Revised

AUTO SHREDDING SUBDIVISION

APPLICATION NUMBER Holdover DATE November 3, 2005

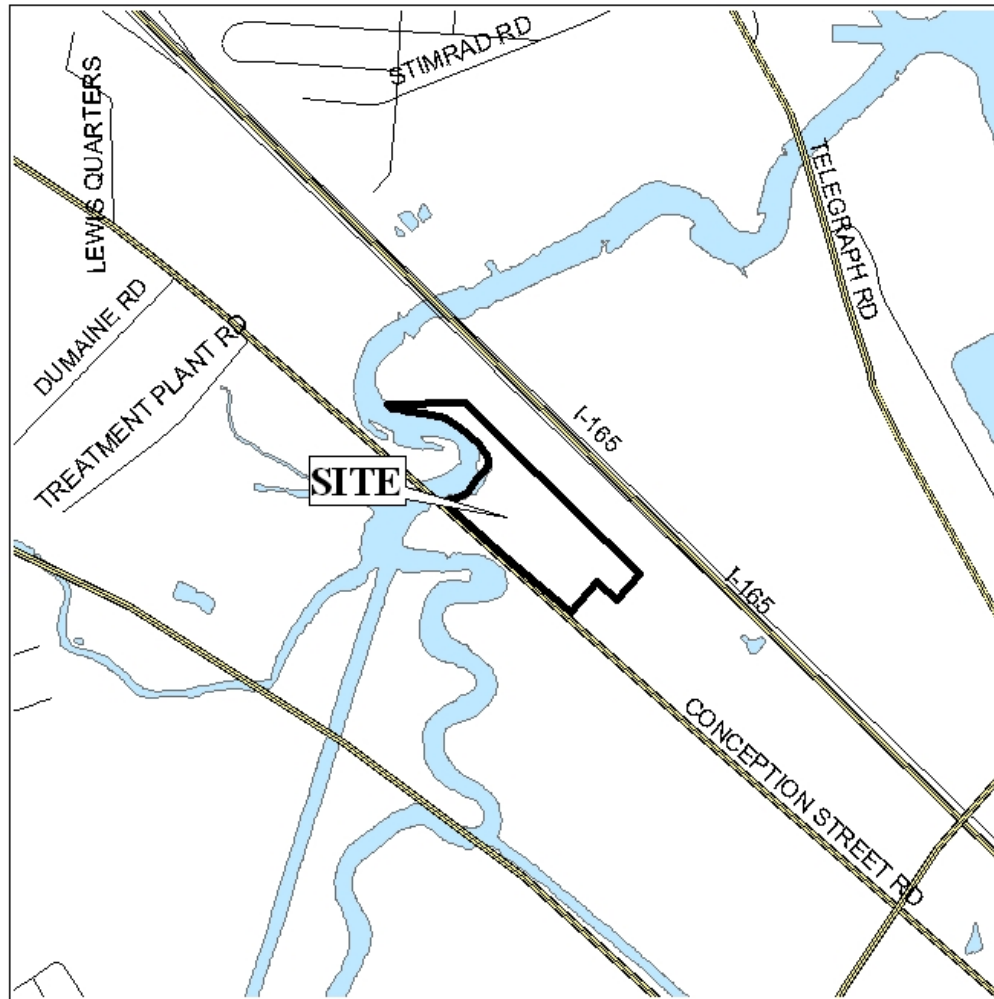
Engineering Comments: Minimum finished floor elevation is required on the final plat. A drainage easement will be required if any portion of this property conveys stormwater runoff from COM rights-of-way. Must comply with all stormwater and flood control ordinances. Any work performed in the right of way will require a right of way permit.

The purpose of the application is to create a two-lot subdivision from two metes and bounds parcels. The plat does not appear to include the entire parent parcel however; southeast of the site is a parcel, created in 1978, after the Subdivision Regulations went into effect. This parcel should be included in the application, with the owner's consent, and additional notice and application fees.

The plat shows a number of existing buildings on the site. Before the final plat is recorded, an application for an Administrative Planned Unit Development should be reviewed and approved by Urban Development.

Based on the preceding, the application is recommended for Holdover until the October 20th meeting, to allow the applicant to include the entire parent parcel in the application, and to revise the plat to include a finished floor elevation, and a drainage easement (if any portion of the property conveys stormwater runoff from COM rights-of-way). Revisions should be received by Urban Development by September 26th.
